As requested, attached are Ford comments, Alliance Comments and Ford comments to the TAR.

Docket ID No. EPA-HQ-OAR-0827

Alliance of Automobile Manufacturers Comments on Draft Technical Assessment Report: Midterm Evaluation of Light-Duty Greenhouse Gas Emission Standards and Corporate Average Fuel Economy Standards for Model Years 2022-2025 (EPA-420-D-16-900, July 2016)

Figure B-5: Effects of D/M on Downsizing Benefit: CAFE Unadjusted Combined Fuel Economy¹⁰⁷

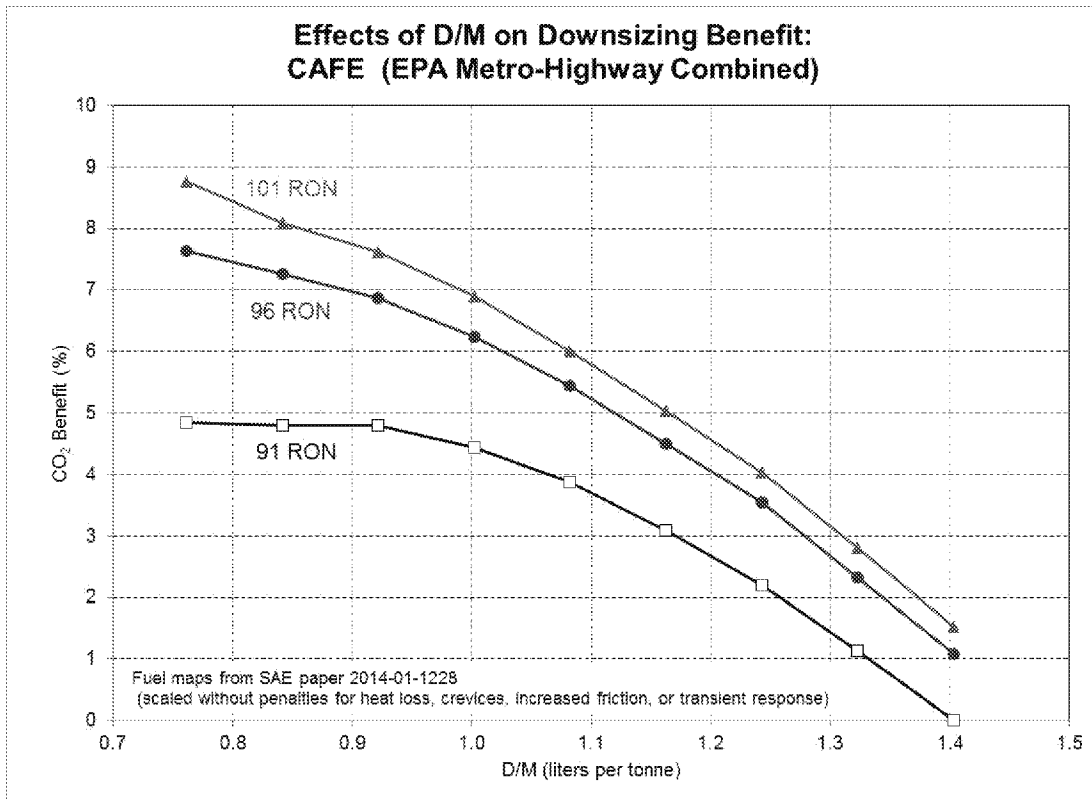
Fuel octane limitations are further demonstrated in Figure B-5 which shows large impacts on fuel consumption at high-load conditions. Note that with moderate downsizing, engine efficiency increases, but aggressive downsizing results in degraded efficiency. This is particularly important because in many cases the Agencies' downsizing assumptions appear to be based on maximizing the efficiency over city and highway test cycles while ignoring efficiency reduction during higher-load driving conditions (for example US06 and high-speed interstate driving conditions). Automakers must consider customer drivability and performance acceptance including high-load driving conditions when determining the appropriate level of downsizing, and cannot implement the level of downsizing based on analysis that is derived solely on operation during certification cycles. Using 91 RON fuel (e.g. Tier 3 fuel) there is no further CO₂ benefit below a displacement-over-mass ratio (D/M) of about 0.9. However, as shown by the 96 RON and 101 RON data in the figure below, the Agency assumptions based on higher-octane fuel would indicate that additional downsizing beyond 0.9 D/M still yields reductions in CO₂.

Figure B-6 Effects of D/M on Downsizing Benefit: On-Road Fuel Economy (Highway Bag of US06 Cycle)¹⁰⁸

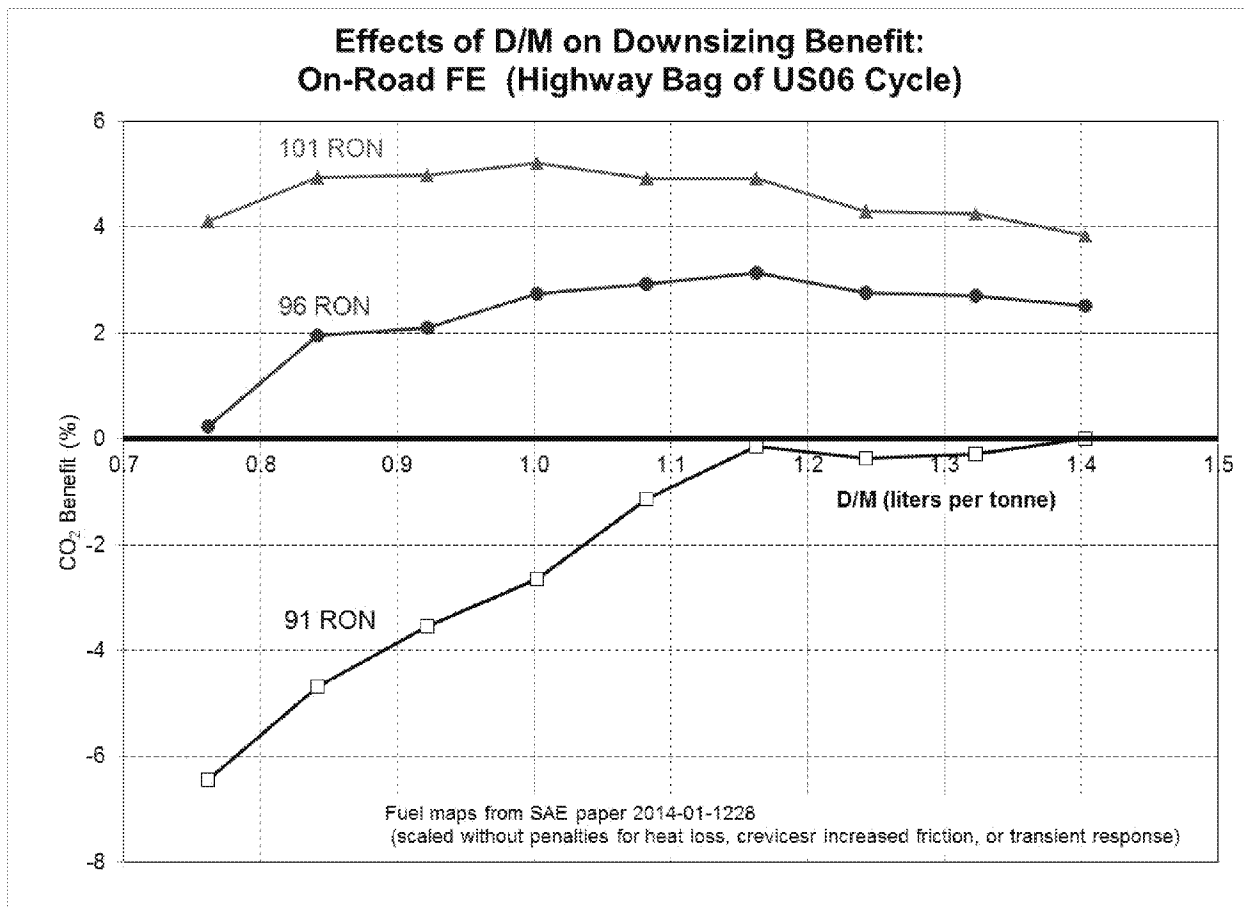
Even more importantly, Figure B-6 below shows that overestimating the degree of downsizing will actually decrease fuel efficiency at higher loads (high-speed on-road driving, US06). This effect is amplified with higher octane fuels. The figure shows decreases in CO₂ benefit for engines with a D/M of 1.2 while using 91 RON fuel.
